PROPERTY PLAT
WM: H. ZIMMER NPS UNIT
C.G.E. CO.
C.S.O.E. CO.
D.F.E.L. CO.

SARGENT & LUNDY
ENGINEERS
CHICAGO
DRAWING NO.
REV.
M-1
SHEET 1 OF 5

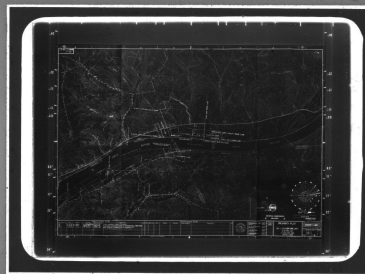
DELETED FOR DESIGN
CHANGED LOCATION HEIGHT OF METEOROLOGICAL TOWER FROM
80 FT. TO 150 FT. (CHANGED SHAPE OF BORROW PIT
COMMENTS MT-100 INCLUDED) (MT-201)
